Department of Energy
Albuquerque Operations Office
P.O. Box 5400
Albuquerque, New Mexico 87185-5400

May 5, 1997

Enclosed are four copies of the final page changes (numbered Attachment 1 through 12) for incorporation into the preliminary final Clive Completion Report, dated March 1996. All of the changes made to the Completion Report, except for the changes discussed in items 9 and 10 below, were necessary to document the corrective action repairs that were recently completed. Corrective action repairs were required because some of the erosion protection material in various areas on the disposal cell did not meet the design intent (see Appendix K of the Completion Report).

**SOUTH CLIVE SITE
URANIUM MILL TAILINGS REMEDIAL ACTION
COMPLETION REPORT**

9705140449-01
FIGURE 5

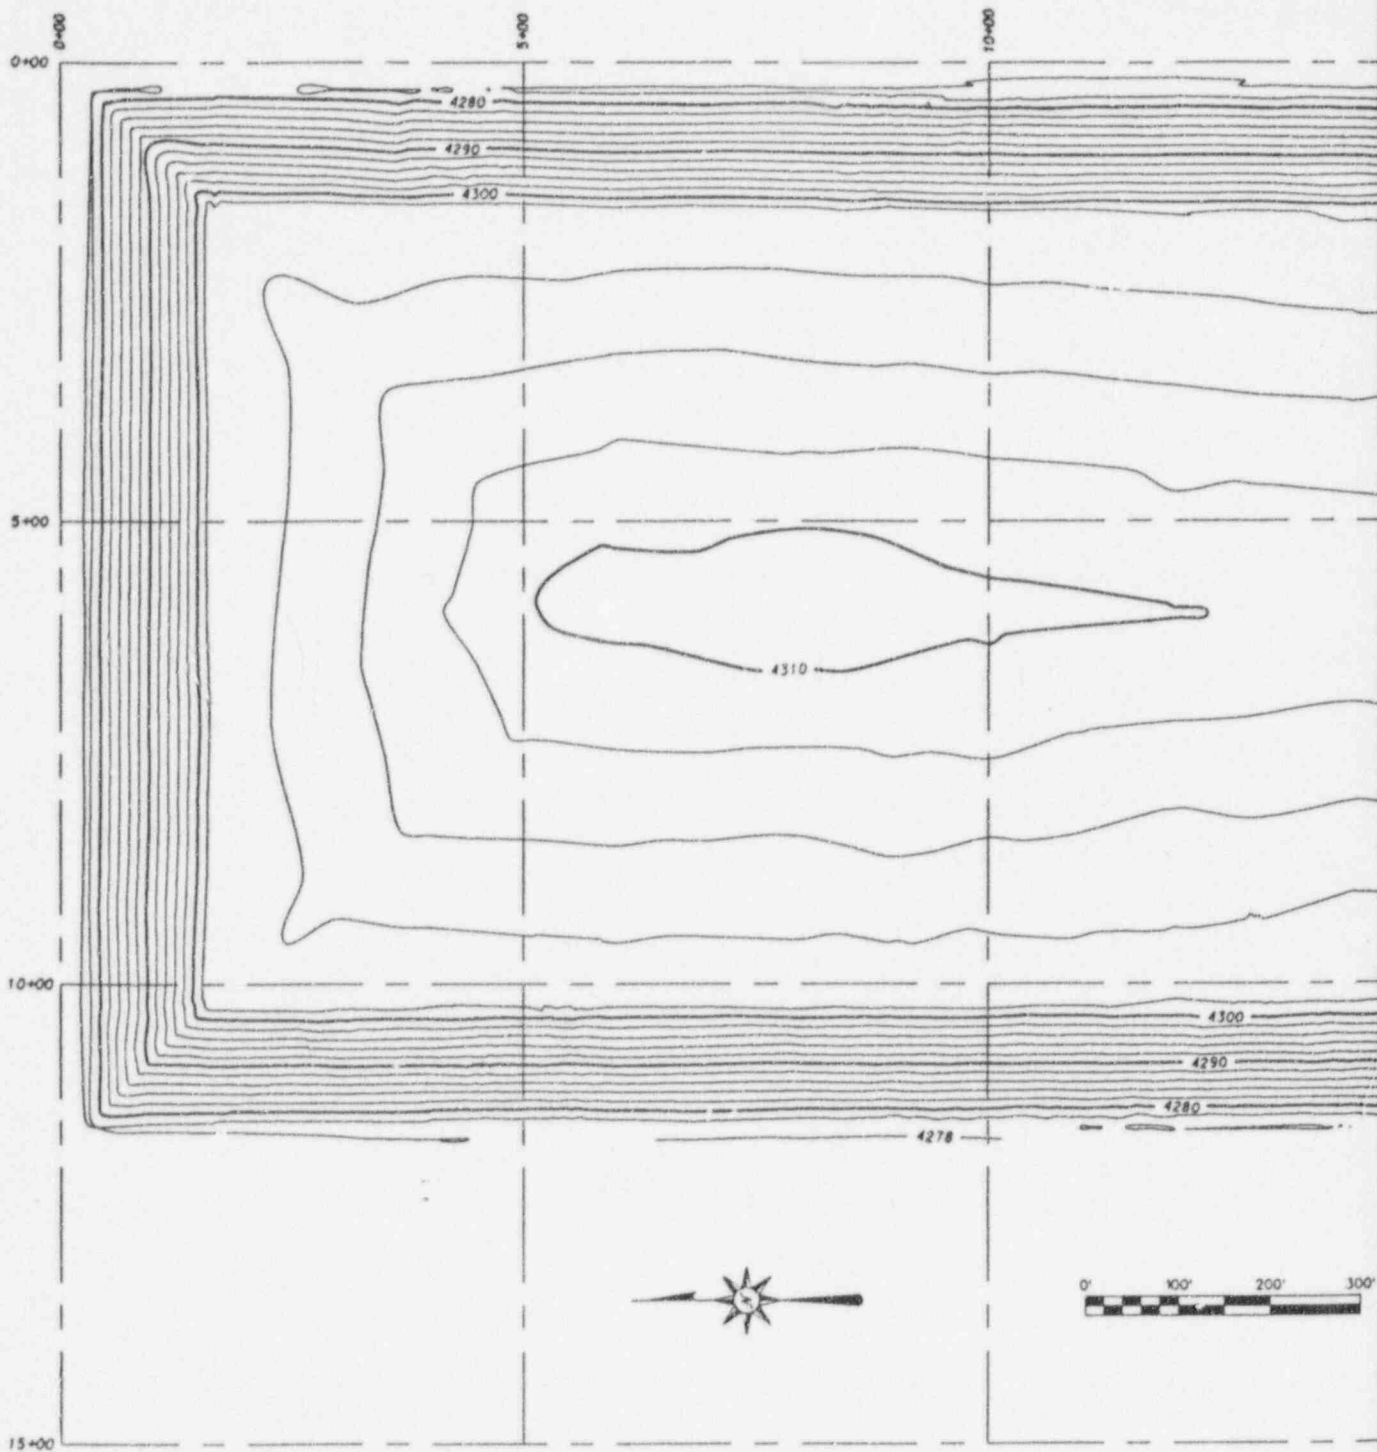
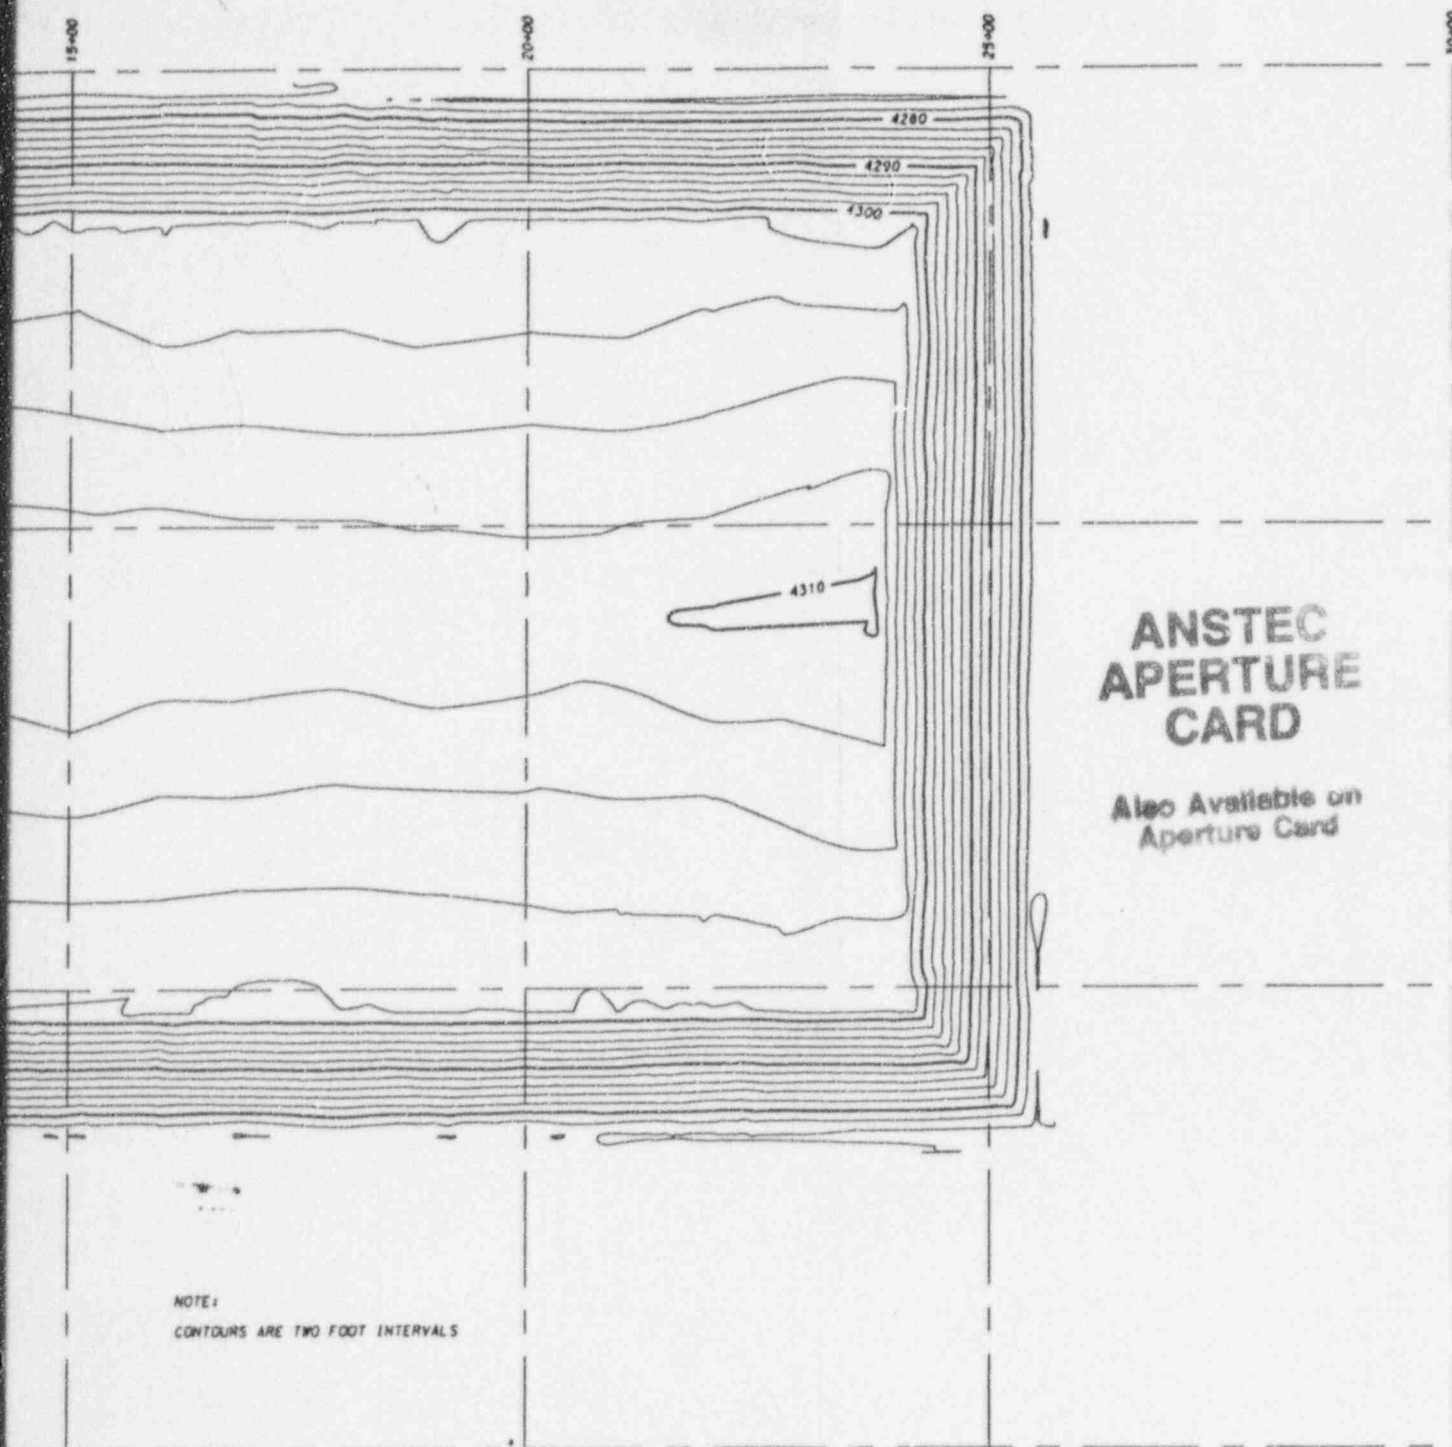
5. Locate Volume 1, Appendix D, As-Built Drawings. Remove and destroy page D-2. Attachment 5 contains the replacement page D-2 and a new as-built drawing labeled Figure 5. Insert replacement page D-2 after page D-1. Insert the new as-built drawing, Figure 5, after Figure 4.

Figure 5 is the final as-built drawing and represents the condition of the cell following rework which was performed from November 1996 through March 1997. (Reference Appendices K and L.)

Figure 5 is the final as-built drawing and represents the condition of the cell following rework which was performed from November 1996 through March 1997. (Reference Appendices K and L.)

EXHIBIT 1

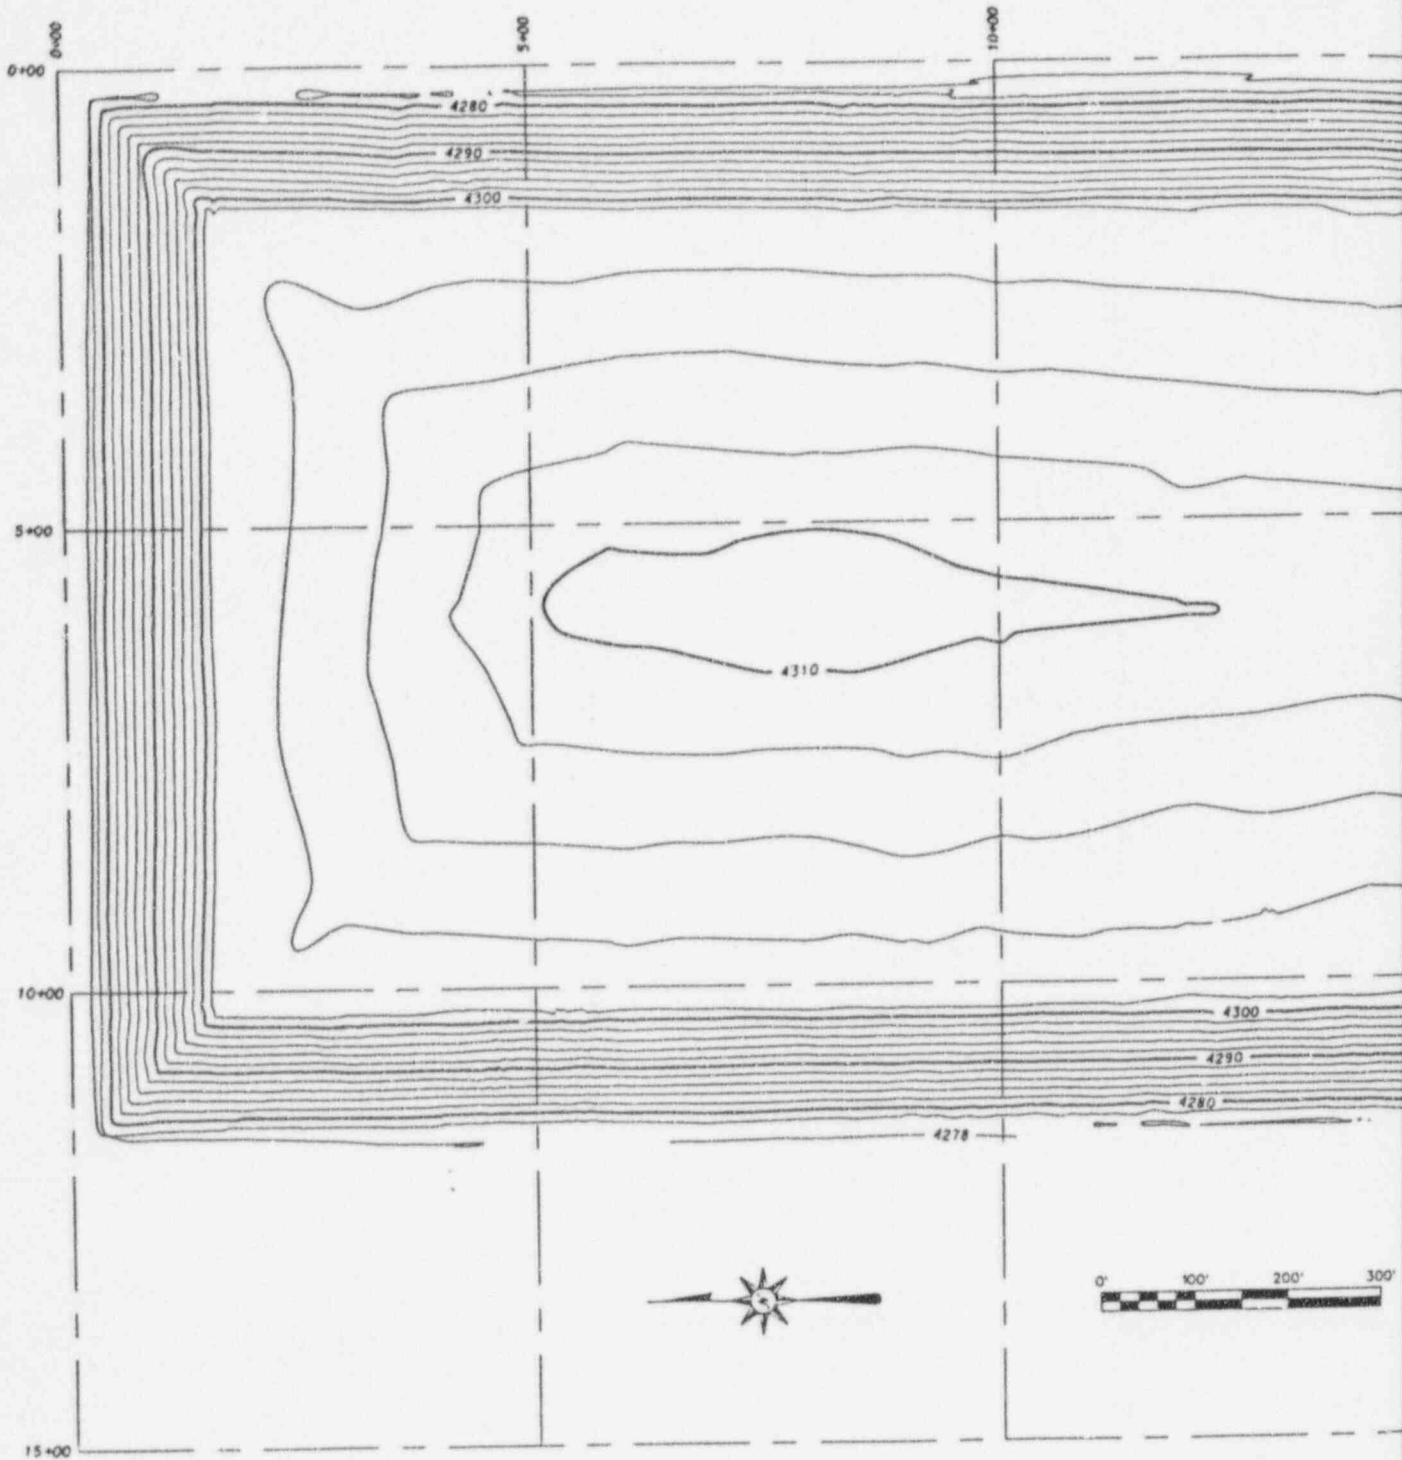
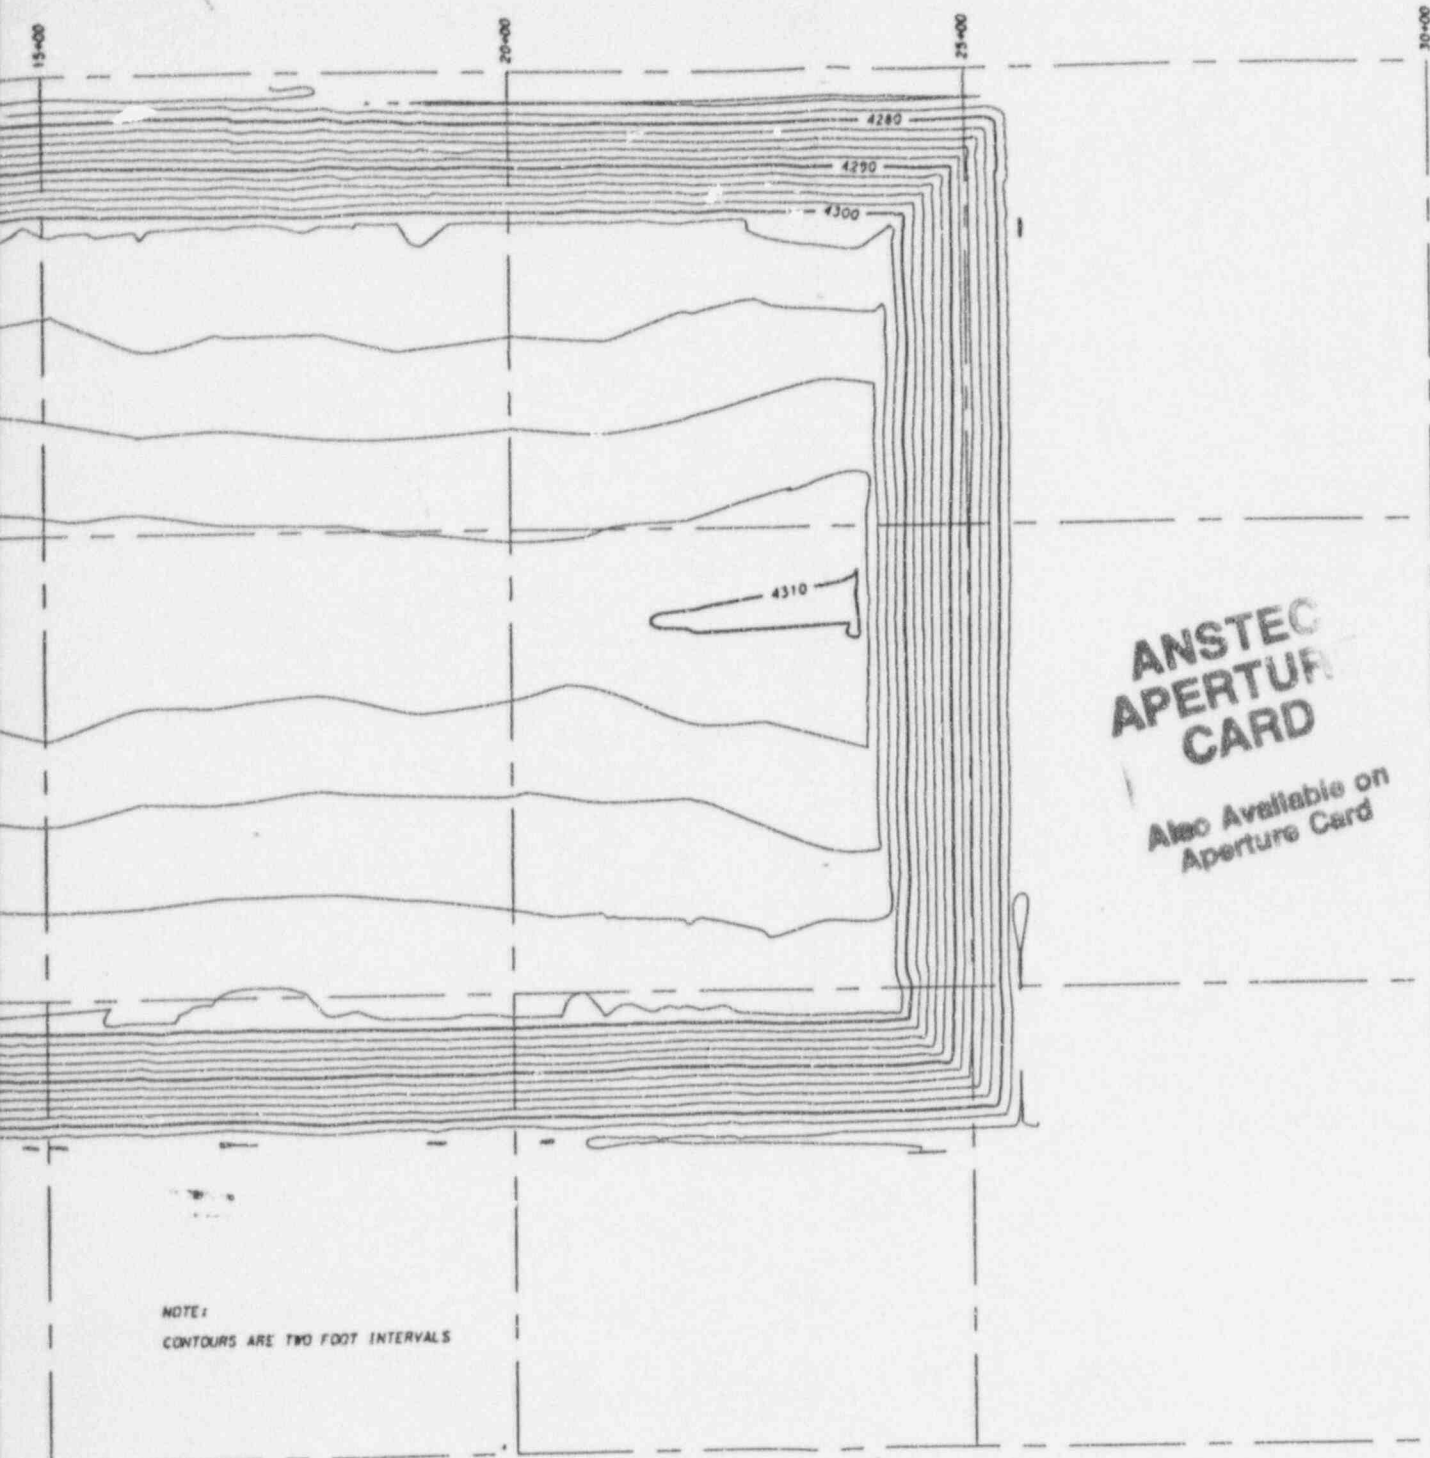
Upon completion of the re-work and re-grading, a final as-built topographical map of the disposal cell was produced. This drawing incorporates all grade changes that were made to the final cover layer. The final as-built topographic map is presented as Exhibit 1.
